BNC Ref. DA156-23
TCC Ref. MCU25/0011

**RE: APPLICANT RESPONSE TO ASSESSMENT MANAGER INFORMATION REQUEST & FURTHER ADVICE NOTICE
DEVELOPMENT APPLICATION FOR A MATERIAL CHANGE OF USE (ROOMING ACCOMMODATION)
94 BERGIN ROAD, CRANBROOK QLD 4814 (RPD: LOT 1 ON RP737431)**

**ASSESSMENT MANAGER INFORMATION REQUEST
TOWNSVILLE CITY COUNCIL**

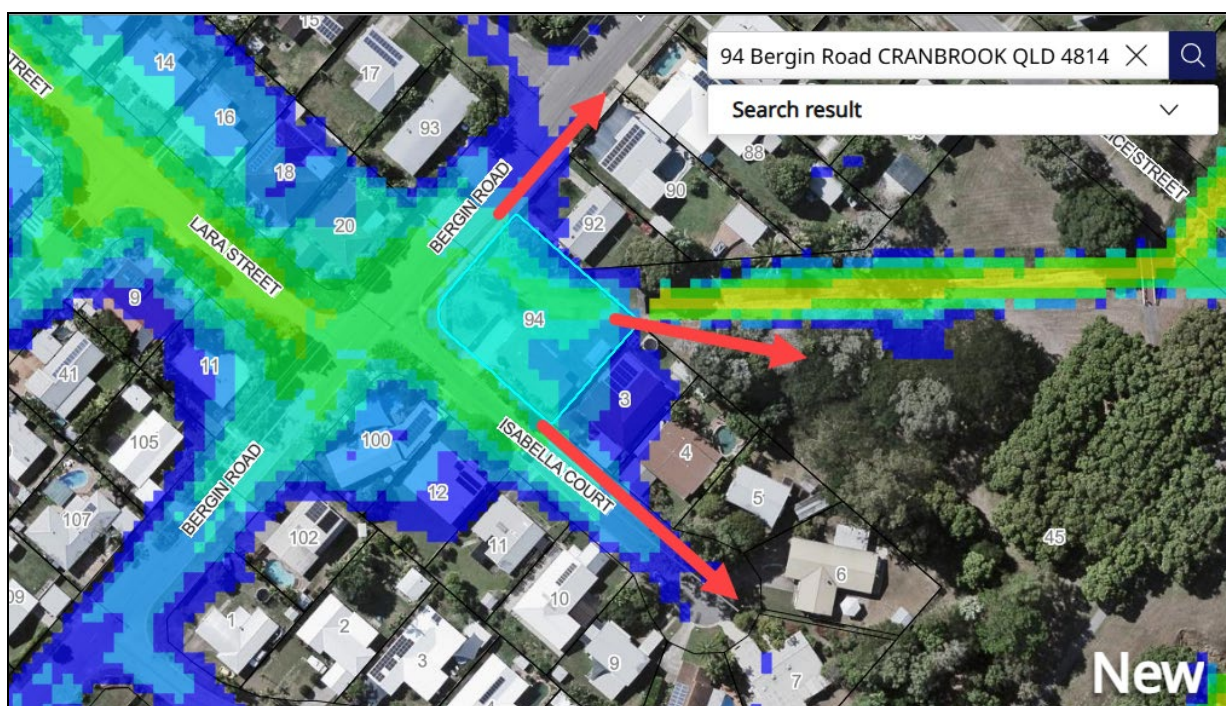
The applicant is advised that the proposed high intensity within the High Flood Hazard area poses an unacceptable level of risk to people or property which will occupy the land and requires further consideration. As per the recent flood model mapping, the development site is mapped as Very High and High Risk with average 1% AEP depth of 0.58m.

The applicant has resolved to reduce the scale of the proposed development which allows for a significant improvement in the ability to manage vulnerability and reduces the risk to people and property from flood hazard to an acceptable/tolerable level. The amended proposal retains the number of rooms but significantly improves the level of vulnerability by replacing ground level floor space with second-storey space and congregating the built form in the lower risk areas of the site. The applicant also provides the attached updated Flood Impact Assessment which undertakes a detailed review of flood risk, both for the dwellings and car park areas, and concludes that the risk is tolerable. Additionally, the applicant offers the attached Emergency Evacuation Plan which outlines a range of operational and behavioral systems that will be put in place as part of managing the rooming accommodation activities. This combined physical and operational mitigation strategies, in conjunction with the design changes made to the building and car park, ensures the risk to people and property is acceptable.

The yet to be adopted new flood risk mapping is acknowledged, as is the updated 1%AEP flood depth data. It is also acknowledged that, under the current planning scheme, the site is mapped across the low, medium and high hazard areas. The attached Flood Impact Assessment reflects this latest data. It is also of significant importance to acknowledge the greater context of the site, specifically the fact that it exists on the fringe of the 1%AEP inundation area, which makes egress and refuge into community land very achievable. Mapping extract below.
